## The Bluff Point Water Supply Plan Is Bad Science

### A Pernicious Idea

**Figure 1. A generalized hydrogeologic cross-section of Virginia Coastal Plain based on the now-obsolete RASA model, showing three Potomac aquifers (USGS PP 1404-F).**

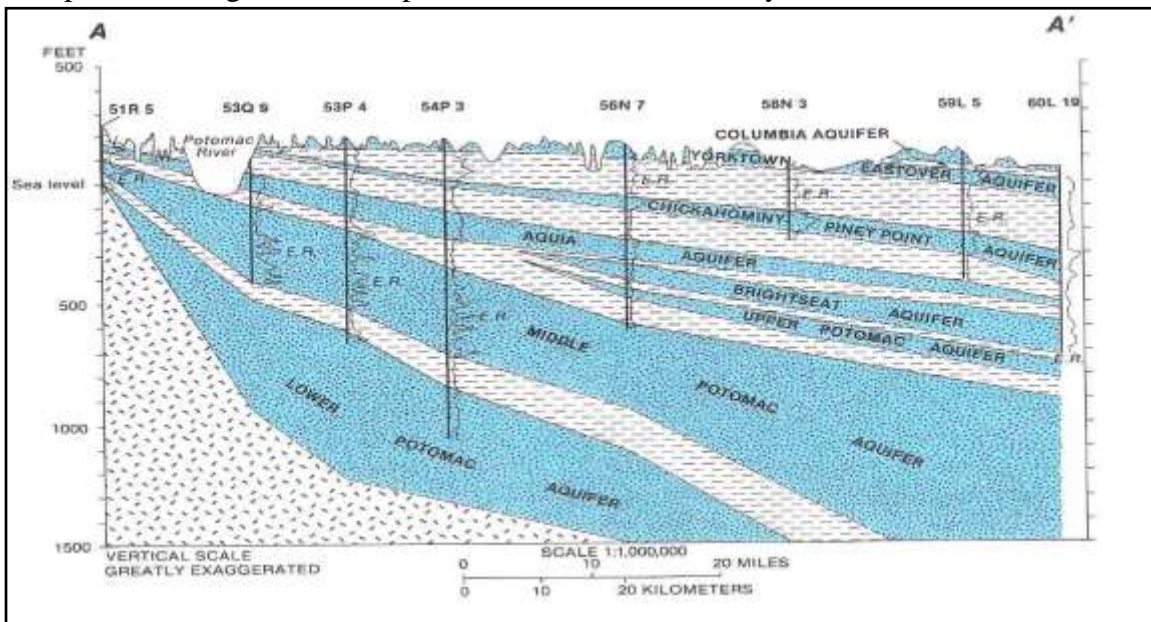
The picture of three separate Potomac aquifers is a sad illusion. The obsolete scheme was developed in the 1980s by staff of the U.S. Geological Survey as part of an attempt to produce a hydrostratigraphic framework of Coastal Plain aquifers (called the *Regional Aquifer-System Analysis*, or RASA), which could be used as a foundation for a computer model of the groundwater system of the Virginia Coastal Plain (see Figure 1). Because of the peculiar design of the computer model, it was necessary to create discrete and

**Figure 2. Conceptual and model representation of aquifers and confining units.**

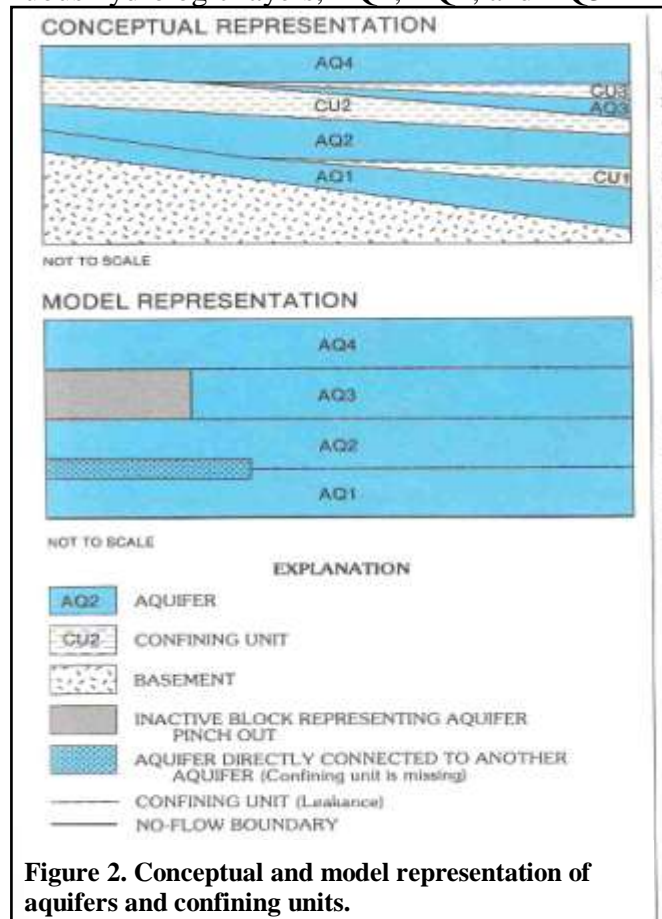
regionally continuous aquifers as model layers (Figure 2, Conceptual Representation) and then reconstruct these layers into a vertical stack (Figure 2, Model Representation). “The quasi-three-dimensional modeling techniques required the designation of separate aquifers to enable the representation of separate model layers needed to simulate vertical [groundwater] flow” (McFarland and Bruce, 2006, USGS PP 1731, p. 32). Thus, despite a paucity of control points and subsurface data, particularly in the Potomac aquifer of the

eastern region of the Northern Neck,<sup>1</sup> the requirements of the computer model dictated the creation of three discrete and continuous hydrologic layers, AQ1, AQ2, and AQ3 (called the Lower, Middle, and Upper Potomac aquifers).

Unfortunately, these three so-called aquifers and the interbedded confining units are, in reality, simply artifices to facilitate computer modeling and not actual rock units. The actual hydro-stratigraphy of the Potomac is far more complex. This distinction is important to understand if one is to recognize the fundamental error in the Bluff Point water plan.

**Figure 3. Illustration of the complex stratigraphy of a heterogeneous aquifer. Notice the absence of discrete, regionally-continuous layers (USGS PP 1731).**

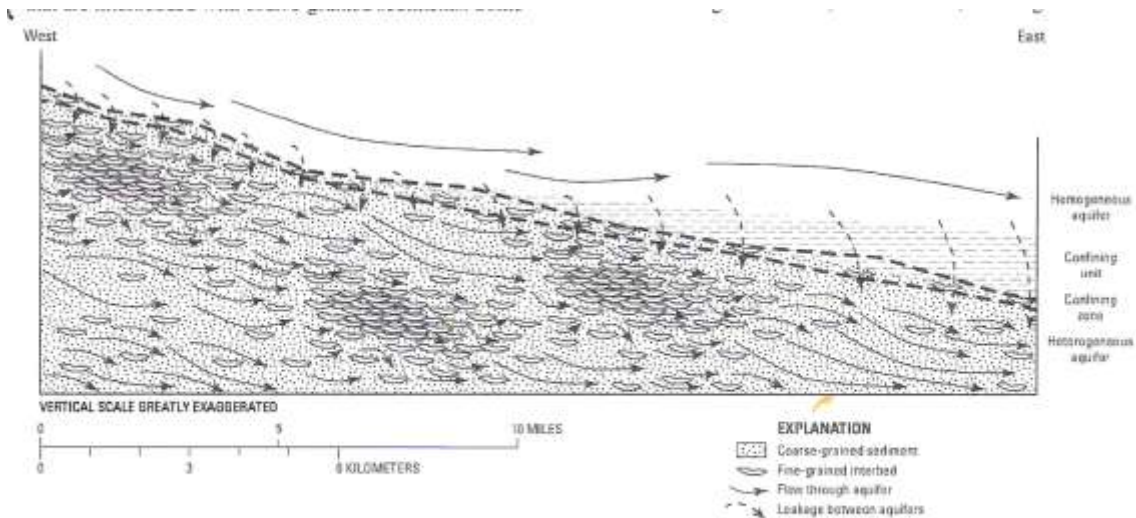
... heterogeneous aquifers [see Figure 3] exhibit sharp contrasts in sediment texture across small distances in the form of discontinuous and locally variable fine-grained sediments that are interbedded with coarse-grained sediments [emphasis added]. Some interbeds have thicknesses as great as several tens of feet and lateral extents of less than one mile. Across some larger areas, interbeds can be densely spaced and partly coalesced, whereas in other areas they can be sparse or absent. Water flows mostly through the coarse-grained sediments, moving around and between relatively stagnant fine-grained interbeds. Thus, heterogeneous aquifers generally are hydraulically continuous at the regional scale but discontinuous locally where flow is impeded by fine-grained interbeds (p. 25).

Figure 4. Models of the depositional environment of the Potomac Formation. Note the heterogeneity of the sedimentary pattern and the absence of continuous layers.

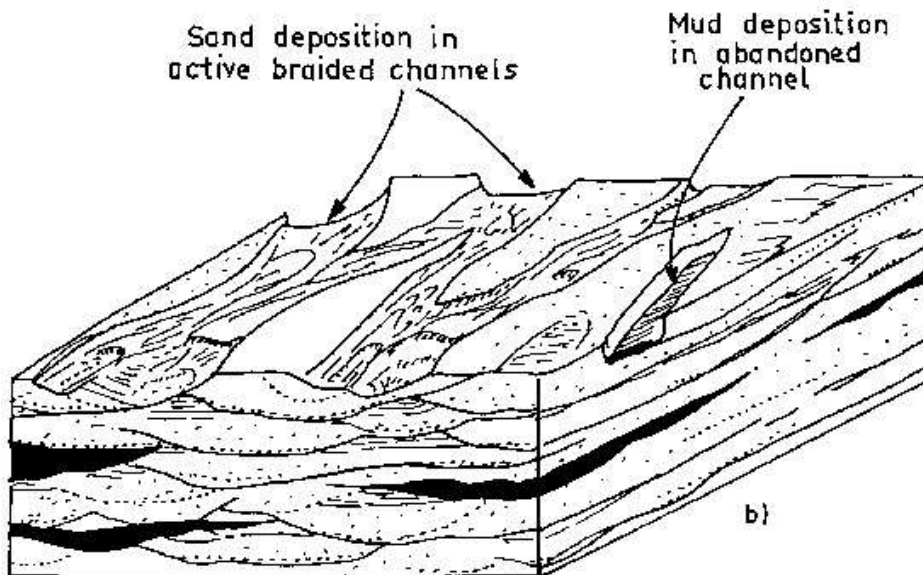
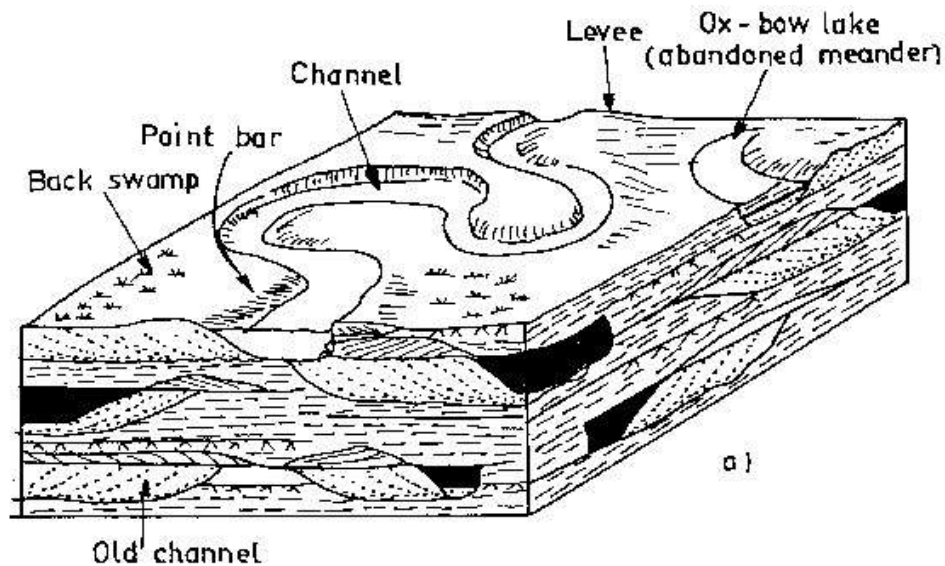
Figure 4 illustrates the depositional environment of the Potomac Formation. This figure demonstrates that the unique hydrostratigraphy of the Potomac sediments is the result of the conditions of their origin. These geologic conditions produce complex sequences of localized gravel, sand, and clay lenses, not homogeneous layers that spread over broad areas of depositional basin.

Figure 5. Hydrogeologic cross-section of aquifers of the Virginia Coastal Plain. Note that the well logs provide geologic information about the upper few hundred feet of the Potomac aquifer only (modified from USGS PP 1731).

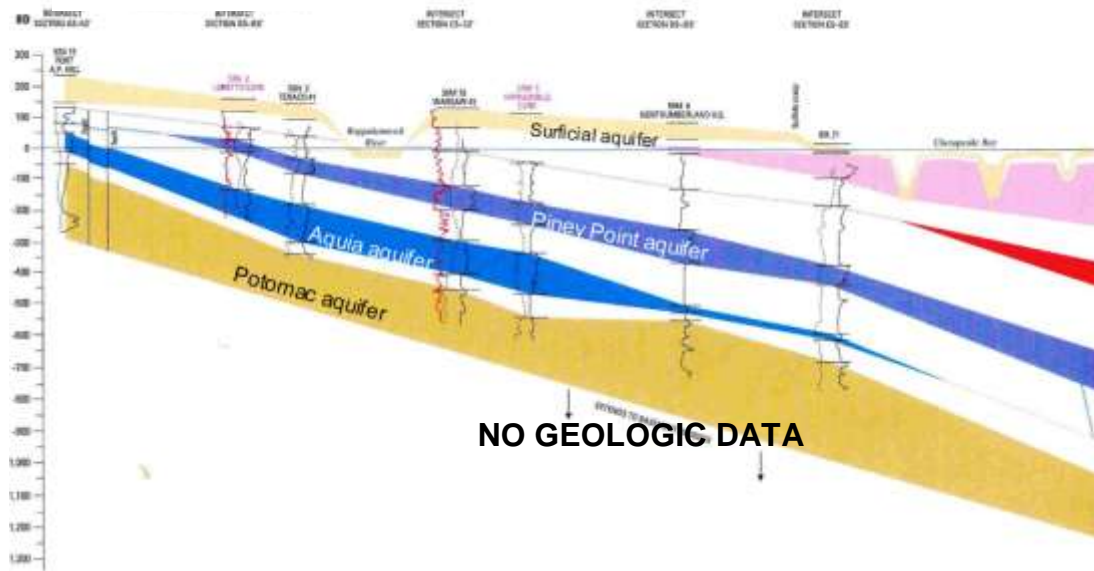
to be drilled into at Bluff Point. The developer's submittal states that the water supply wells will tap groundwater at altitudes of roughly 1,000 to 1,200 feet below sea level. No well in Northumberland or Lancaster County has ever penetrated this deep. (The State Observation Well at Surprise Hill [Northumberland County], the nearest control well, reached a depth of approximately 977 feet below sea level.) What is worse, there are no bore holes or observation wells within 50 miles or so that penetrate the Potomac Formation to the level of Bluff Point's intended groundwater withdrawals (see the well logs on Figure 5). Moreover, in light of the absence of rock core samples beneath the site of Bluff Point and the adjacent region, together with the absence of hydraulic testing of Potomac sediments in the vicinity of Bluff Point, continued advancement of the flawed water supply plan demonstrates a reckless disregard for the facts
